Kewaunee / Point Beach Nuclear  
Operated by Nuclear Management Company, LLC

NRC-02-108

Docket 50-305  
Operating License DPR-43  
Kewaunee Nuclear Power Plant  
Response to Request for Additional Information Related to Proposed Revision to the Kewaunee Nuclear Power Plant Technical Specifications LAR 185, "Core Operating Limits Report"

**ATTACHMENT 1**

Figure 2  
Required Shutdown Reactivity vs Boron Concentration

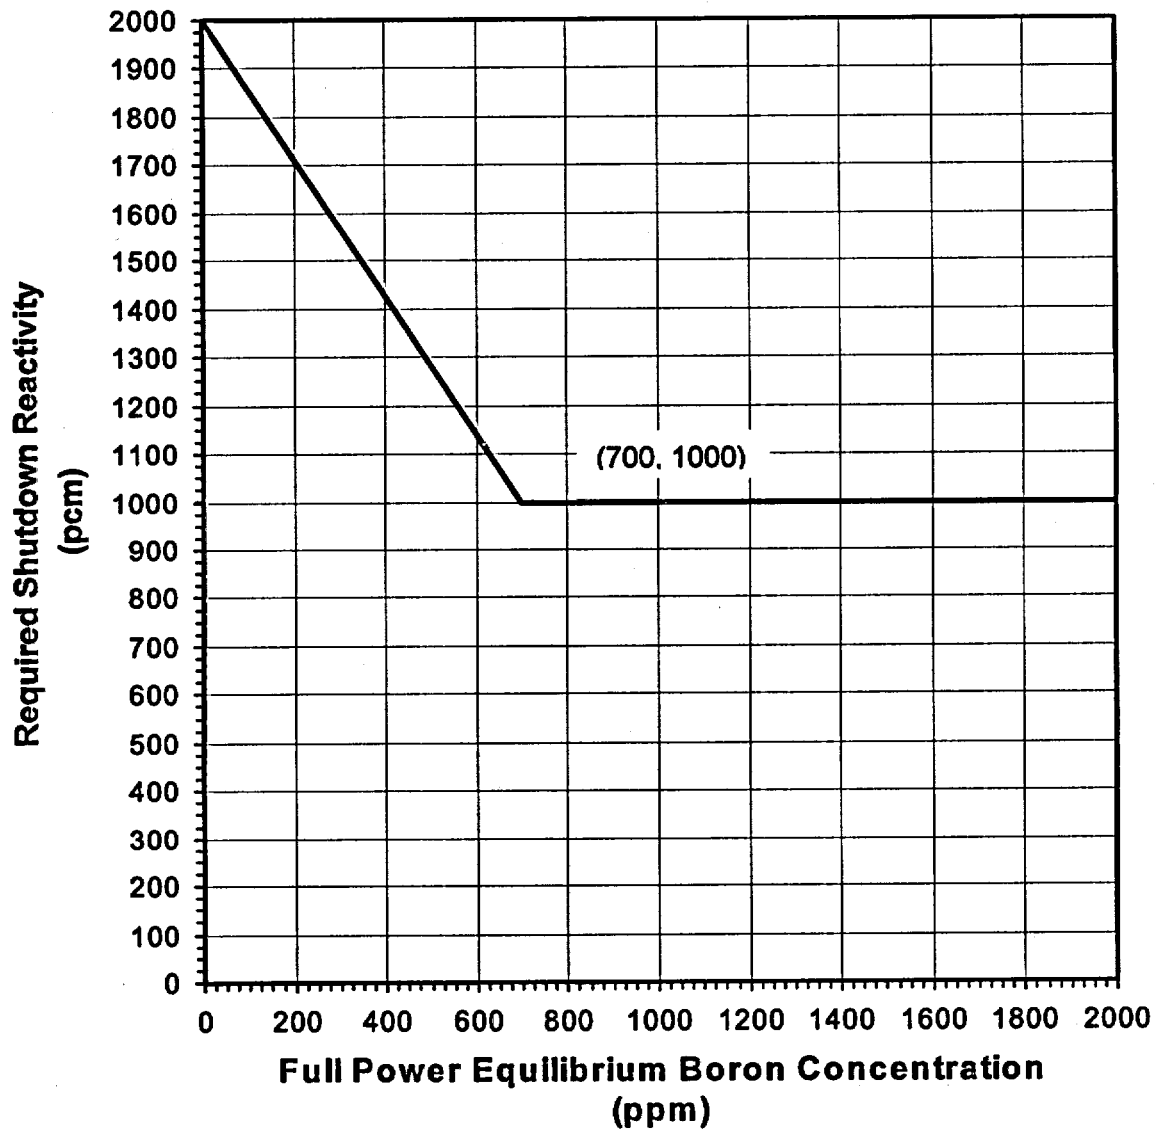
Your proposed Figure 2 of the COLR does not match the original Figure TS 3.10-1. Specifically, the required shutdown reactivity at 0 full power equilibrium boron concentration increased from 2000 pcm to 2200 pcm. Why is this change acceptable? Did you perform a 50.59 evaluation for this change?

This change from 2000 ppm to 2200 ppm is an administrative error. The limit of 2000 ppm is the correct value and the figure has been corrected in this submittal.
